"S" ZONE APPROVAL AMENDMENT NO. SA2006-41

Accessory Structures, Perimeter Fence and Site Lighting at 1608 Pebble Beach Court (APN 029 55 019)

Planning Commission Recommended Approval: August 23, 2006

MILPITAS PLANNING COMMISSION AGENDA REPORT

LIGHTING PLAN

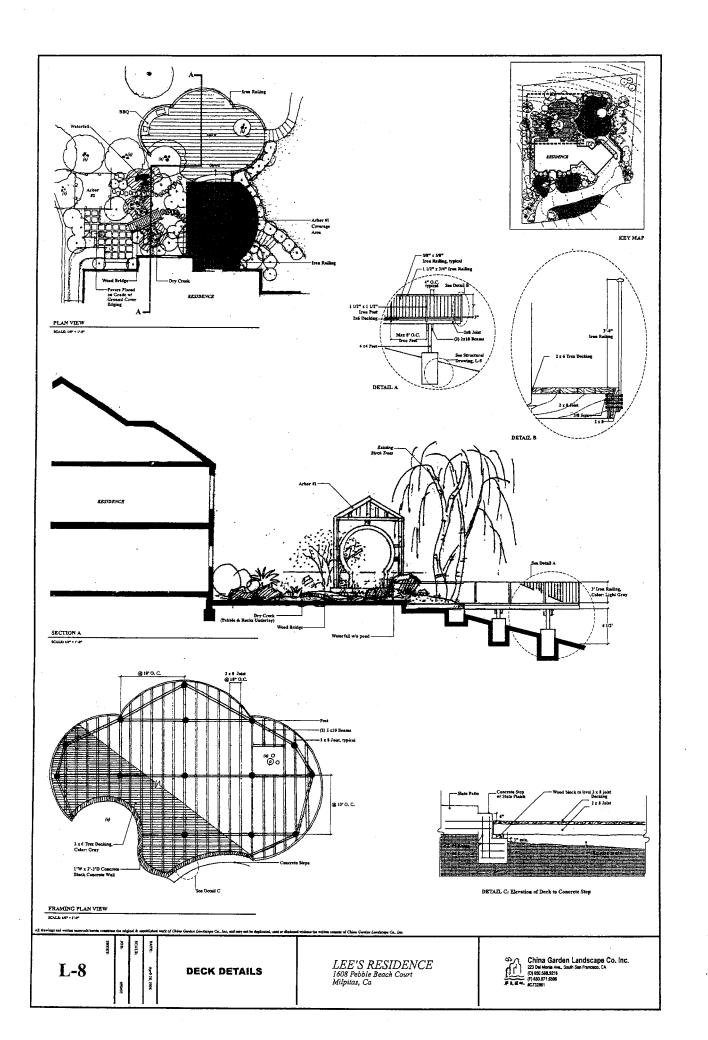
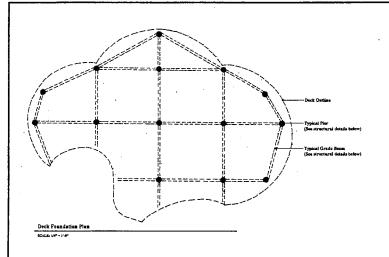
Pursuant to Section 45.15 (Outdoor Lighting) of the Hillside Ordinance, outdoor lighting should use minimum wattage lights, which are shielded so as not to be directly visible from off-site. The applicant proposes three types of light fixtures to replace existing light fixtures. A total of 27 path lights will be installed with a 0.2-foot foot-candle light source. The path lights are 8.25 inches in height and will illuminate the front driveway area and paths in the back yard. 18 spotlights are also proposed to light up trees in the front and rear yards. The spotlights are 5.3 inches in height and will be directed up from the base of the tree. There will be four (4) post

lights at the two driveway entrances, one on each side of the driveway. The post lights will be situated on a three-foot posts with gray slate tiles. The post lights are glass with a brass finish and the brightness is proposed to be 1-foot candle. **Staff recommends** the following conditions that would achieve the objective of the ordinance:

- Reduce the wattage of the site lighting that will safely illuminate the immediate area, yet not be visible from off-site, and;
- Submit details of the replacement light fixtures for the post lights for Planning Staff approval to ensure they properly prevent illumination of adjoining properties or the creation of objectionable visual impacts on other properties or roadways.

- 2. Prior to building permit issuance, the applicant shall reduce the wattage of all the site lighting to a level acceptable to the Planning staff, that will safely illuminate the immediate area yet not be visible from off-site. (P)

- 3. Prior to any building permit issuance, the applicant shall submit details of the replacement post light fixture for Planning Staff approval to ensure they properly prevent illumination of adjoining properties or the creation of objectionable visual impacts on other properties or roadways. (P)
